Corpus Christi ATCT
6902 McGloin Road
Corpus Christi, TX 78415

Memorandum

Date: 2/18/2014
To: Corpus Christi International Airport Aviation Community
From:  David J. Moreno, Air Traffic Manager, Corpus Christi, TX ATCT (CRP)
Subject: Changes at Corpus Christi International Airport

CHANGES TO THE AIRPORT

AIRPORT DIAGRAM

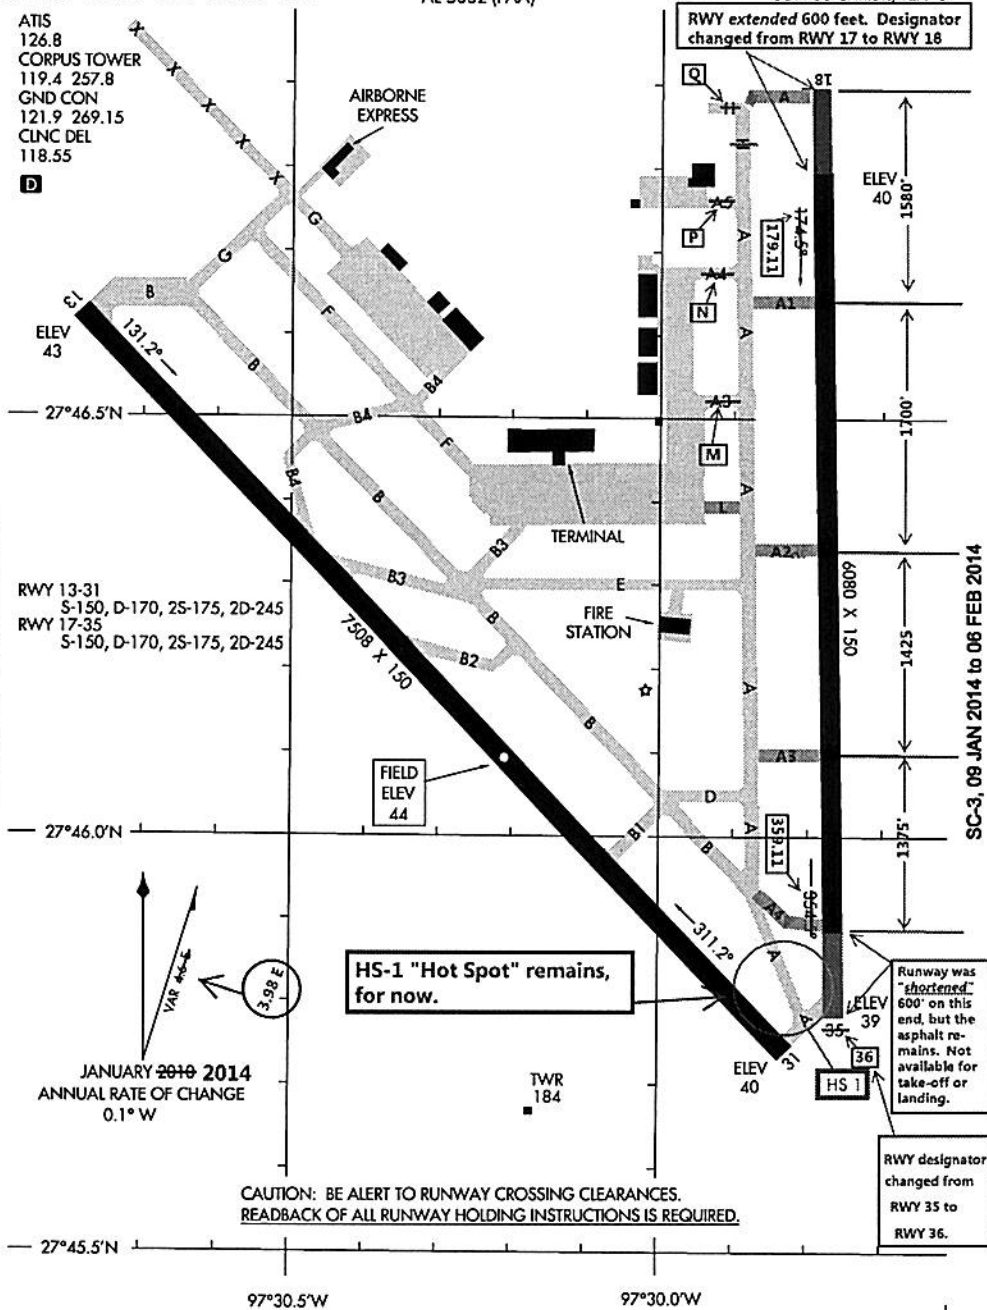
- a. The approach end of Runway 36 was extended north 600 feet, and the approach end of Runway 18 was moved north 600 feet. The net effect is that the entire runway was "shifted north" 600 feet. The actual, available runway length was not increased. It remains 6080 feet.

- e. The east side taxiways have been completely restructured and renamed to enhance safety.
 - i. All taxiways to Runway 18/36 now terminate at the runway at 90-degree intersections. This enables proper scanning of the runway

AIRBORNE
EXPRESSRWY extended 600 feet. Designator
changed from RWY 17 to RWY 18
